Form 3160-5
(June 2019)

SUNDRY NOTICES AND REPORTS ON WELLS
Do not use this form for proposals to drill or to re-enter an abandoned well. Use Form 3160-3 (APD) for such proposals.

8. Well Name and No. HAWK 35 FED/302H

EOG respectfully requests an amendment to our approved APD for this well to reflect the following changes:

Proposed 11" Hole with 9.625" 40# J55/HCK55 LTC Casing

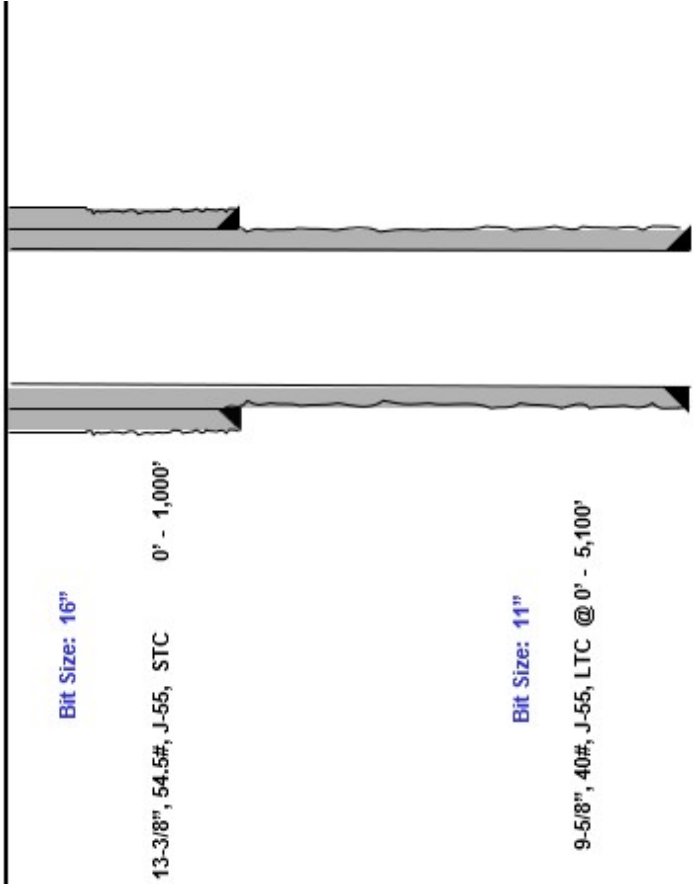
Design A

- 11" Bit + 0.52" Average hole enlargement = 11.52" Hole Size
 - 0.9475" Clearance to casing OD
$$= \frac{11.52 - 9.625}{2}$$
 - 0.4475" Clearance to coupling OD
$$= \frac{11.52 - 10.625}{2}$$
- Previous Shoe – 13.375" 54.5# J55 STC
 - 0.995" Clearance to coupling OD (~1,200' overlap)
$$= \frac{12.615 - 10.625}{2}$$

Proposed 9.875" Hole with 8.625" 32# J55/P110 BTC-SC Casing

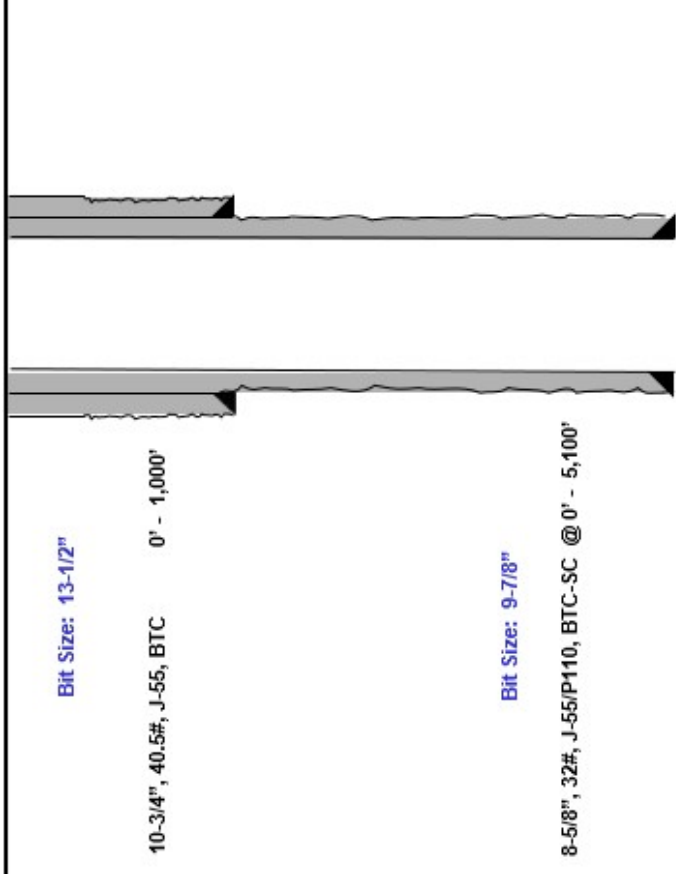
Design B

- 9.875" Bit + 0.42" Average hole enlargement = 10.295" Hole Size
 - 0.835" Clearance to casing OD
$$= \frac{10.295 - 8.625}{2}$$
 - 0.585" Clearance to coupling OD
$$= \frac{10.295 - 9.125}{2}$$
- Previous Shoe – 10.75" 40.5# J55 STC
 - 0.4625" Clearance to coupling OD (~1,200' overlap)
$$= \frac{10.05 - 9.125}{2}$$
